CCK-2583.2-1-24 Nutter Field House Gymnastics ADDENDUM # 1 9/18/2023

Nutter Field House Gymnastics JRA Project No. 202305 UK Project CCK-2583.2-1-24 University of Kentucky Lexington, Kentucky

The Addendum will form a part of the Contract Documents and modifies the original Bidding Documents dated September 2023.

A-104

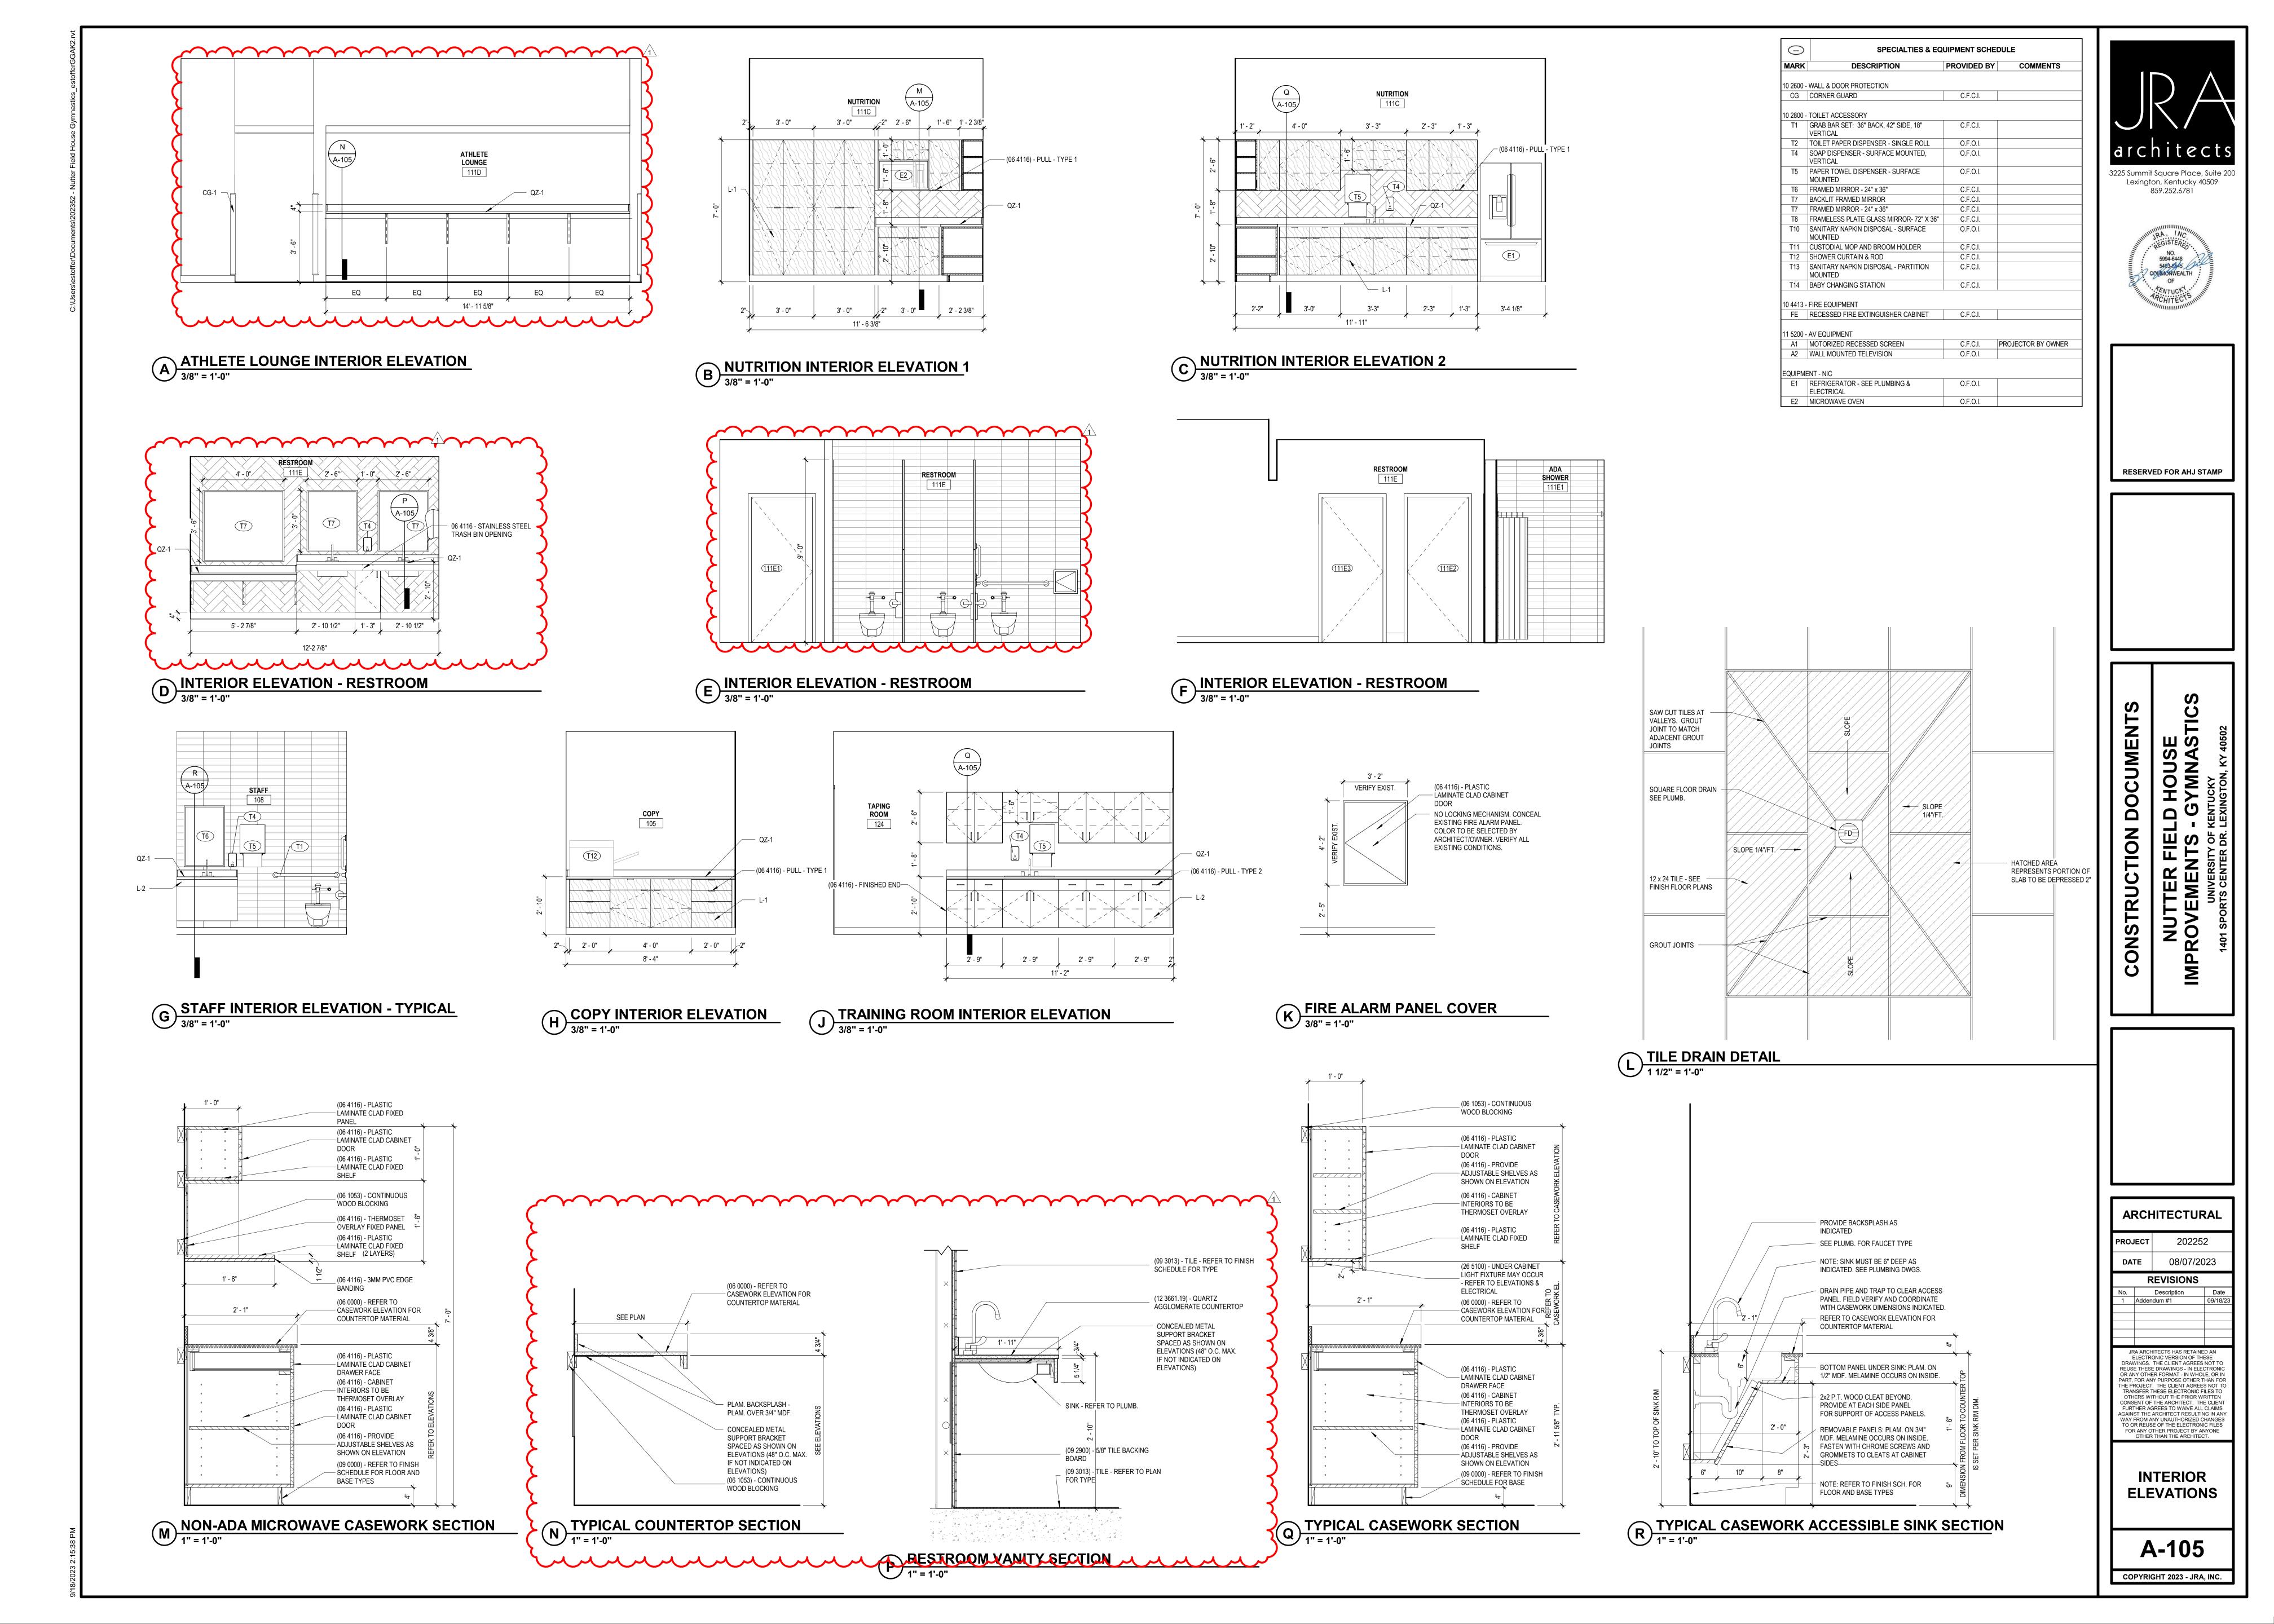
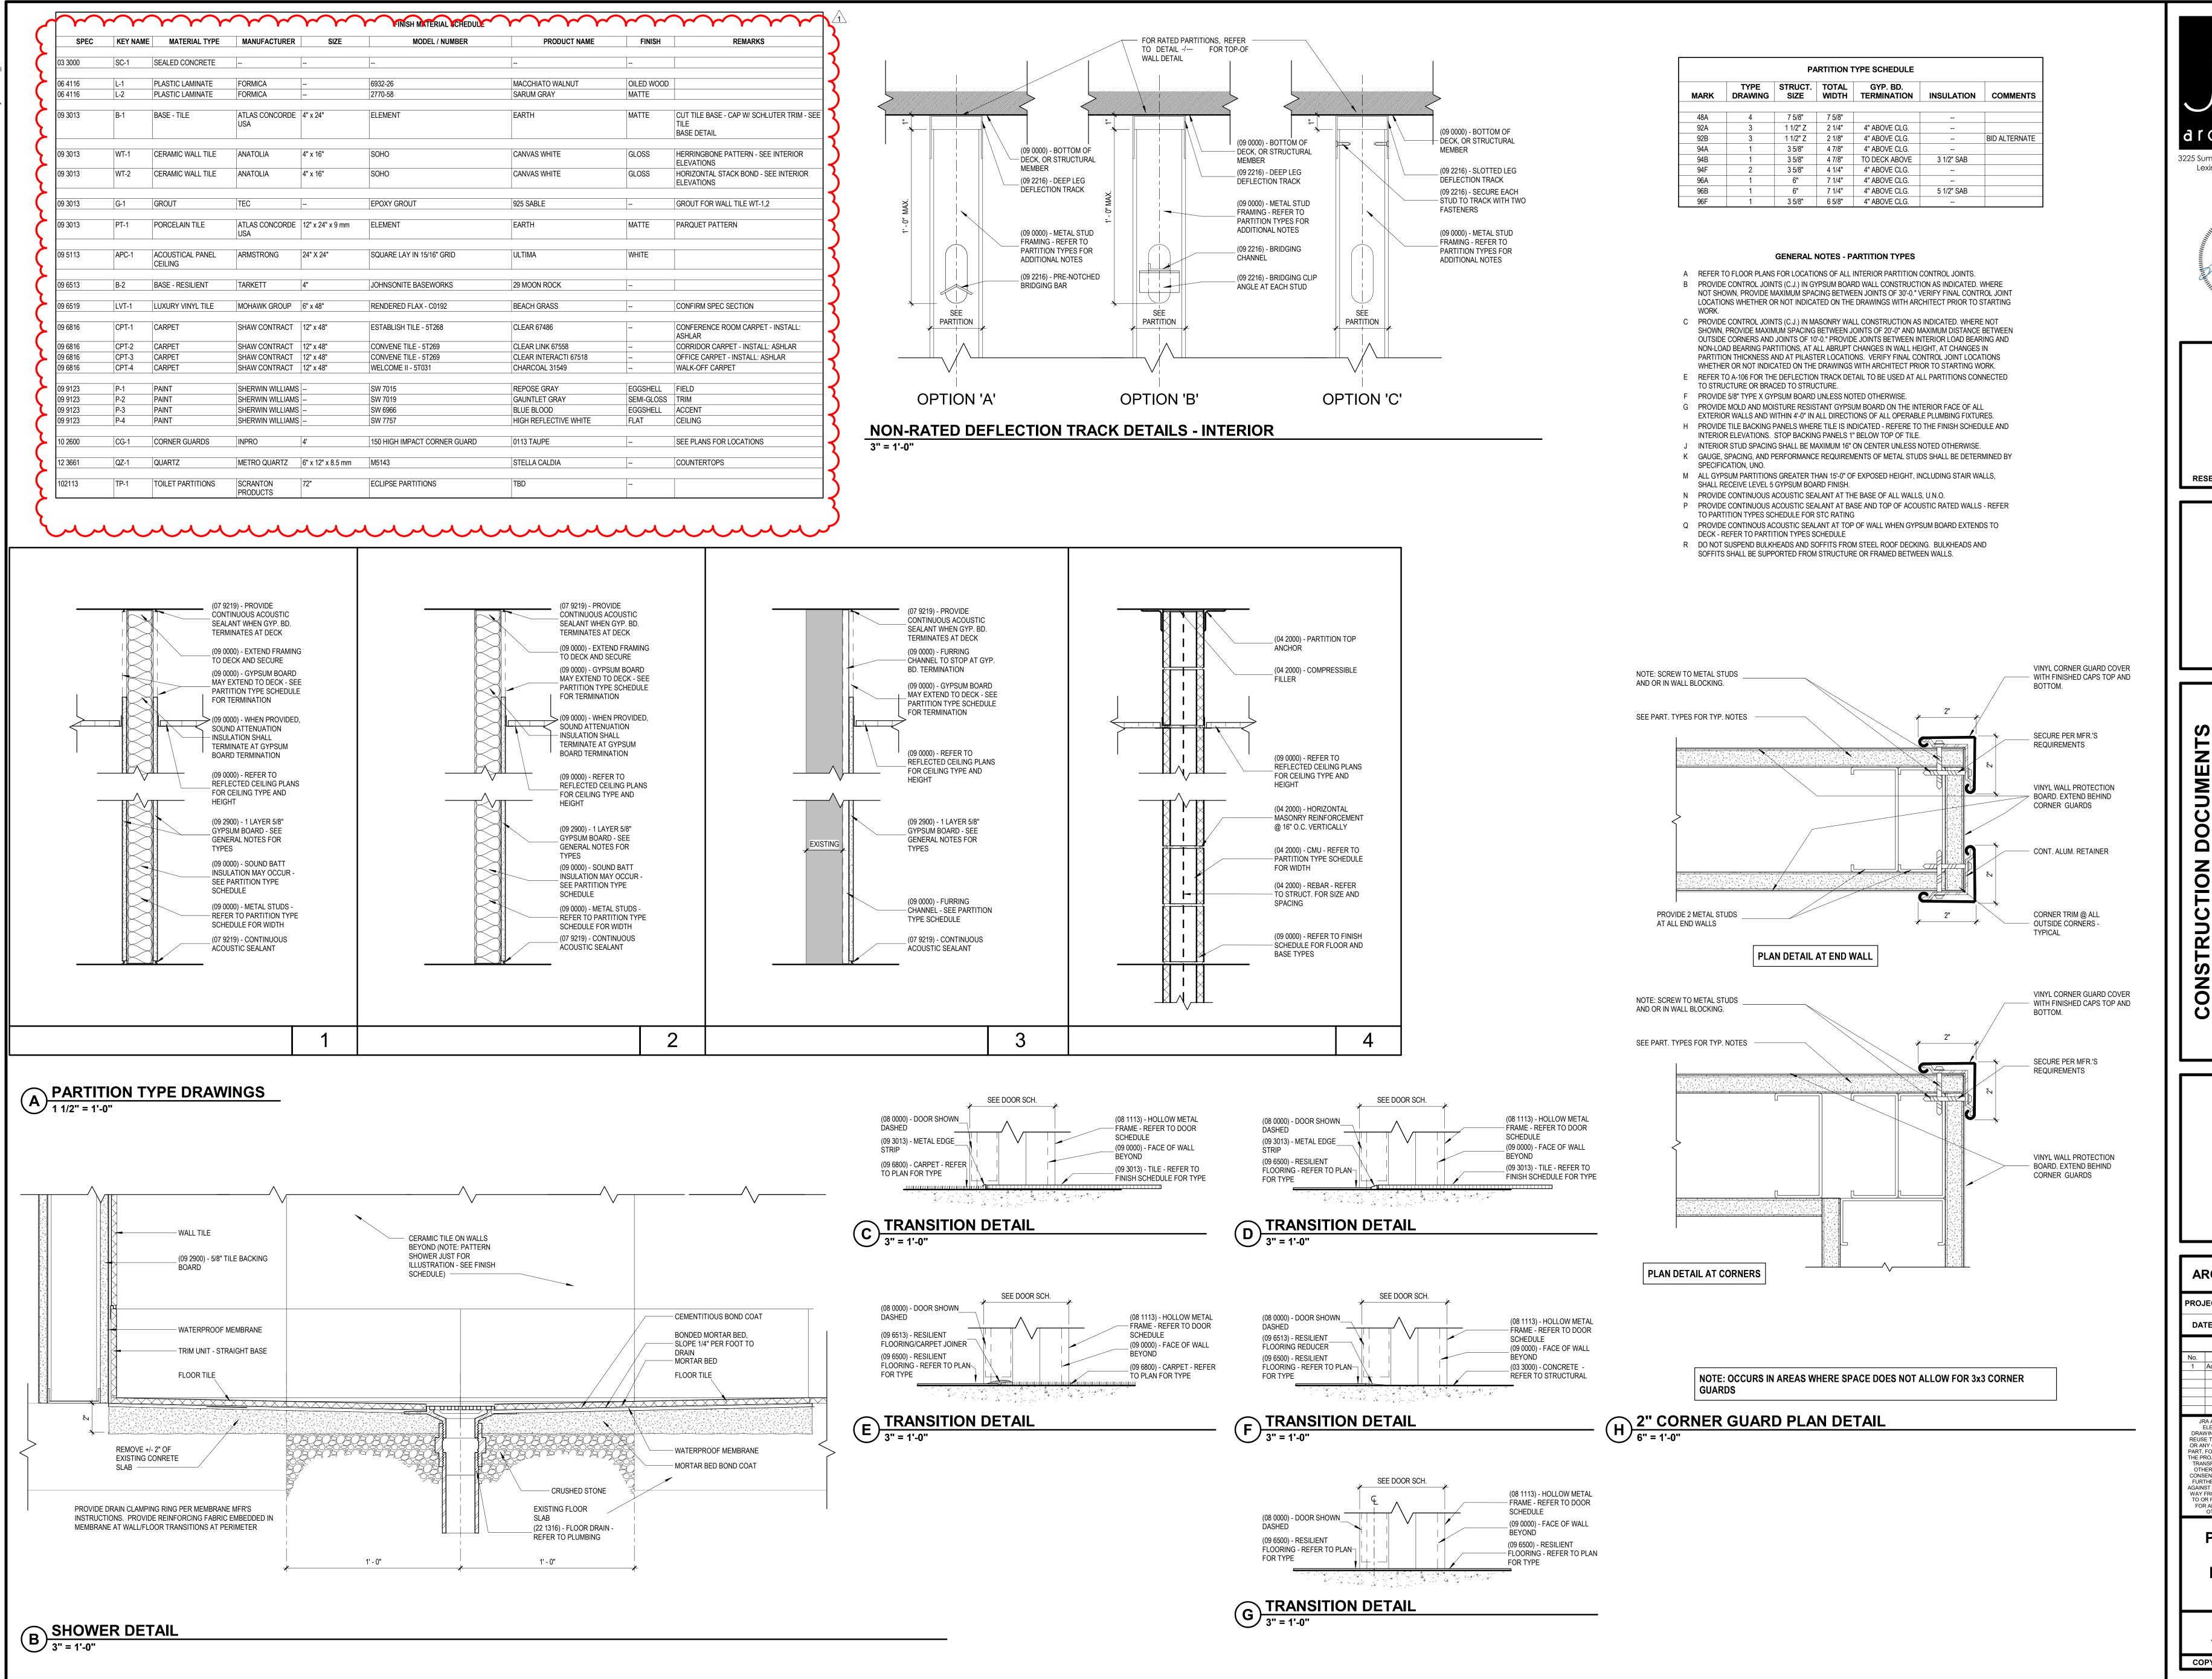
Adjusted finish schedule, finish material schedule and finish plan for clarity. See attached sheets A-104, A-106

Omit Sign Type D. See attached sheet A-104.

E-001

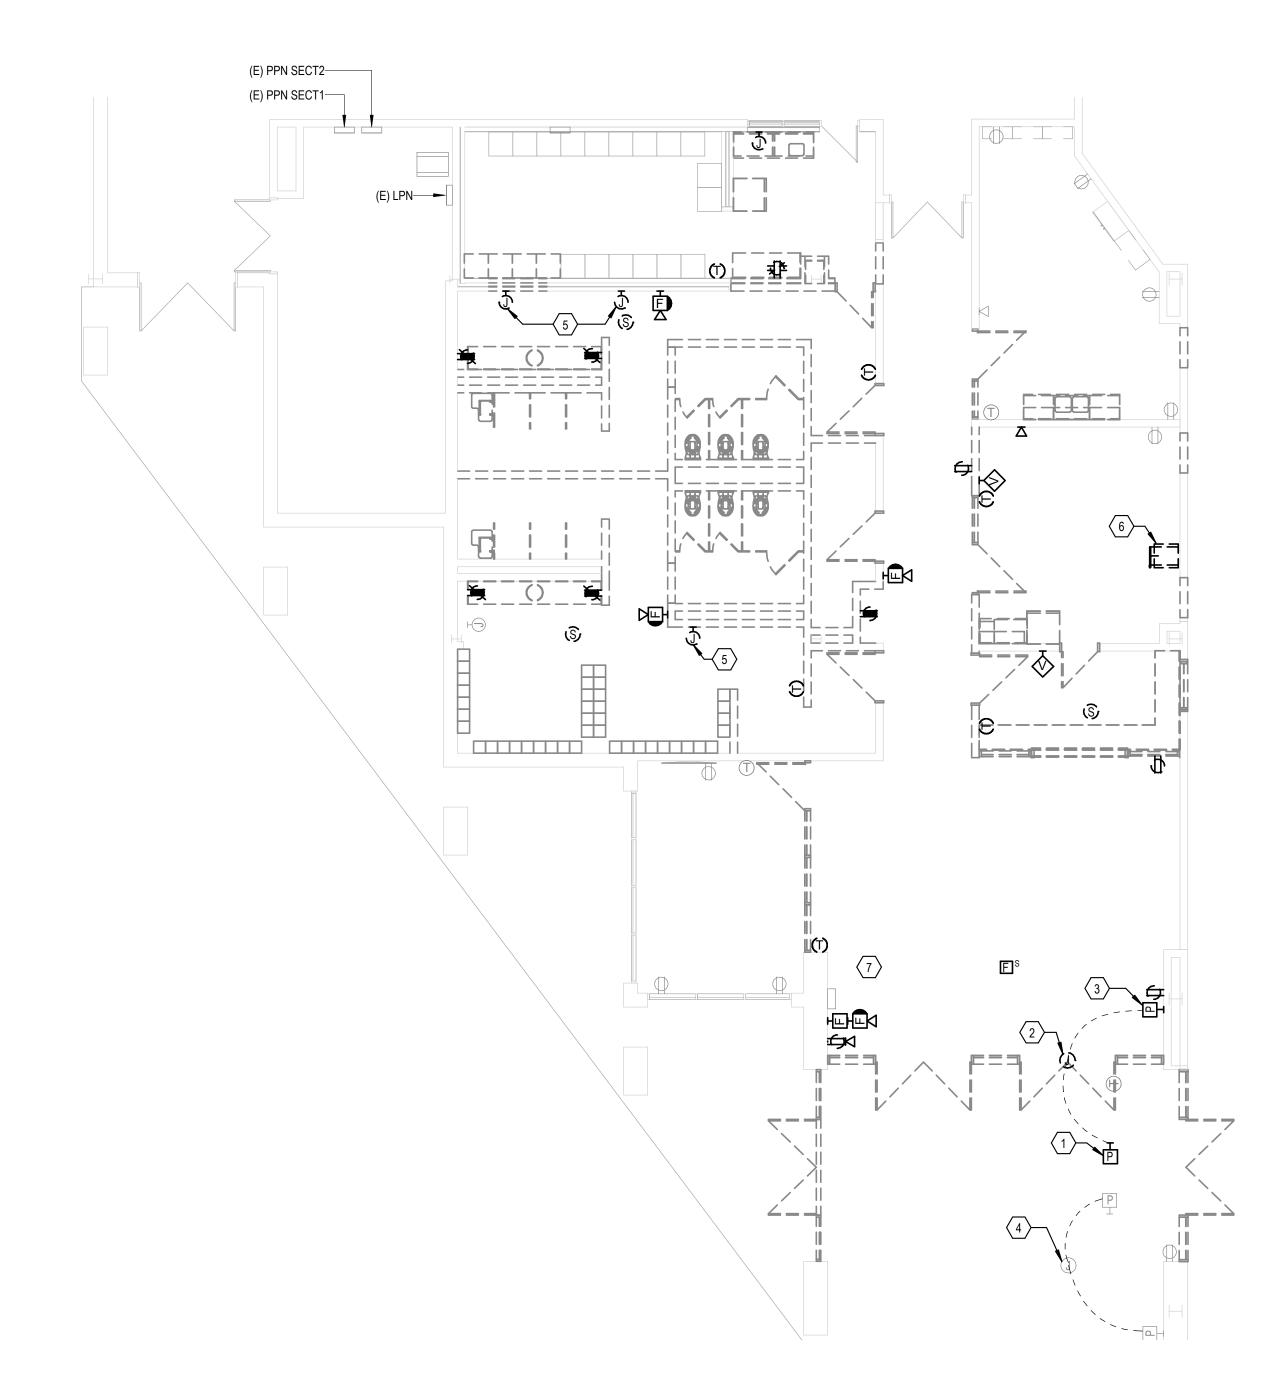
Sheet: E-001 - FIRST FLOOR ELECTRICAL DEMOLITION PLAN

Summary of Changes: Level 01 Ceiling Demolition Plan revised to clarify electrical devices for removal.
